33521AN-01

Modification Recommended Service Note

33521AN Function Generator

Serial Numbers: SG00000000 to SG57000600

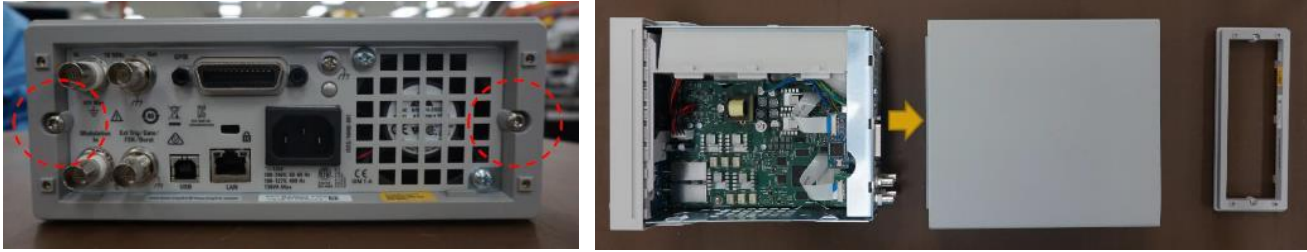
The Problem – Some customers have reported that, when line power is applied to the instrument but the instrument is NOT turned on (“Standby Mode”), some instruments will emit an audible high-pitched whistle or whine. To fix this, the existing power supply must be replaced with a newly designed power supply, as detailed in the solution below.

The solution is to replace the old power supply with a new one. The old power supply was manufactured by XP Power. The new power supply is manufactured by MeanWell, and has Part Number 0950-6082.

Old Noisy XP Power Supply (PN xxxx-xxxx)

New MeanWell Power Supply (PN 0950-6082)
